Paul Zacher-Structural Engineers

re: Job 98228: YOUNG

Subject: Structural Investigation Report of the Roof for the Residence located at 7256 Bayview Way, Sacramento, CA 95831.

① ROOF PLAN - YOUNG
N.T.S.

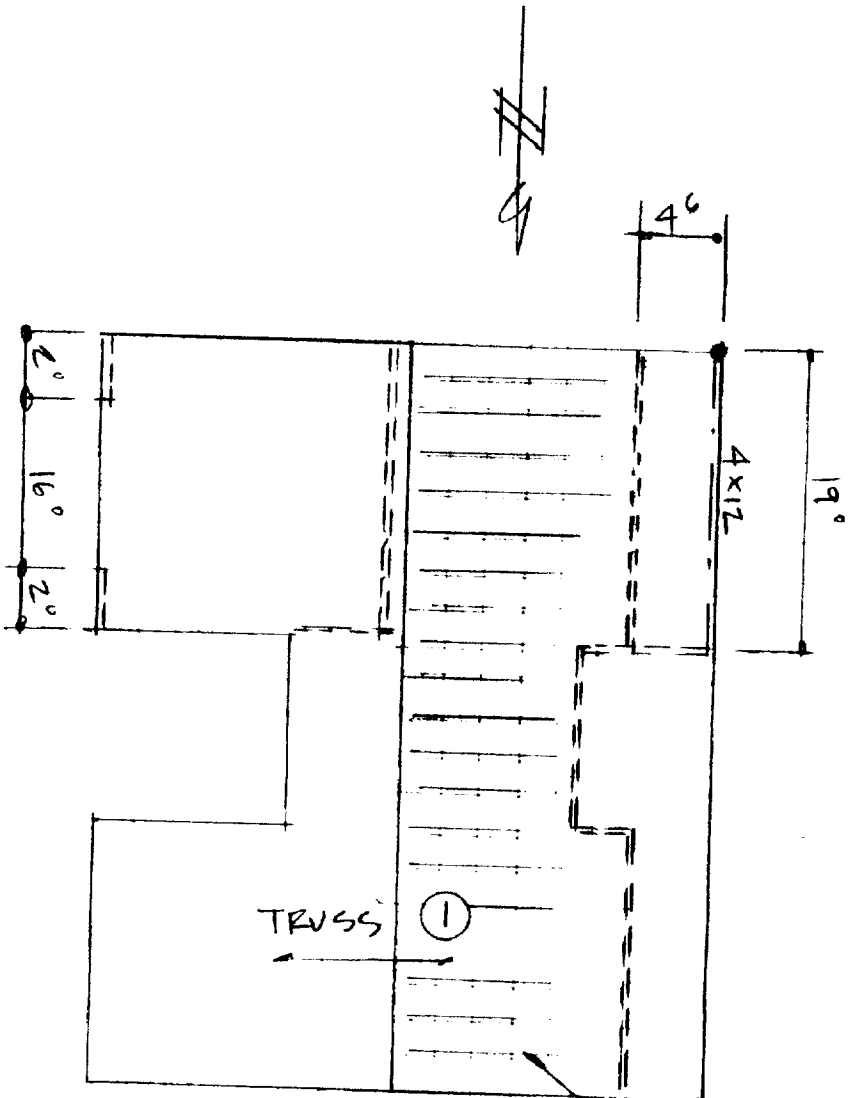
The living area lacks sufficient structural capacity for the applied live and dead loads. The garage has sufficient structural capacity for the applied live and dead loads.

1. Scab a 2x8 rafter to the existing 2x4 top chord with 16d's @ 12" on center where the span is greater than 16'-0".

SCAB 2x8x19" TO EXISTING 2x4 TOP CHOPED MEMBER THAT SPANS 16" (APPROX 20)
